Office Action Summary

10/784,316

SWANSON ET AL.

FIG. 4

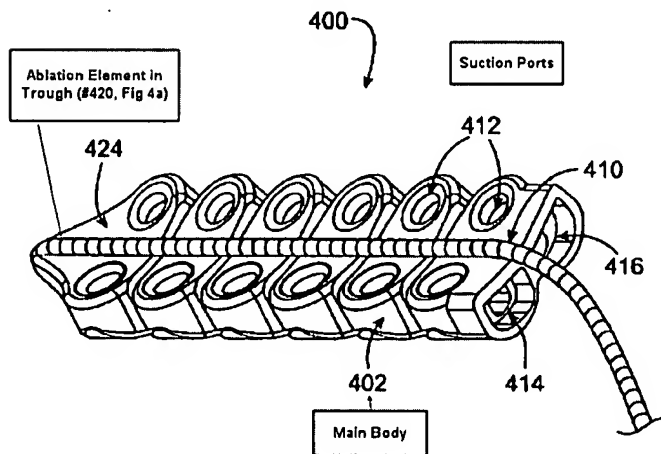
Claims 1-11, 13-27 and 29-38 are rejected under 35 U.S.C. 102(e) as being anticipated by U.S. Patent 6,849,075 to Bertolero. Bertolero et al. teach a device for holding an ablation (electrophysiology) device including a trough (Fig. 4a, # 420) wherein the ablation member (Fig.

4, # 410) may be a removable piece which may be removably attached to tissue contacting member (Fig. 4, # 402), at least partially disposed within a trough (Col. 16, lines 44-54). The ablation element is interpreted as an operative element. Multiple suction ports (Fig. 4, # 412) are disclosed, the area with the ports is interpreted as a bottom surface. The

ports are clearly longitudinally spaced. The trough is interpreted as a connector. The area around the ports can be interpreted as a wall and the bottom area is broadly interpreted as a suction region. Some means is required to connect the suction ports to the suction lumen, such connection interpreted as an aperture. The suction lumens are connected to a suction source via suction lines (Fig 6). The tissue contacting member is of a flexible material (Col. 16, line 3), implicitly making the suction apertures flexible and the trough (connector) flexible. Bertolero et al. disclose cooling of the ablation device by a cooling member with fluid inlets and outlets that allow passage of fluids from the ablation device, the ablation device inherently must have complementary lumens and fluid outlets to allow such passage (Claim 71). That passage would be within the connection trough.
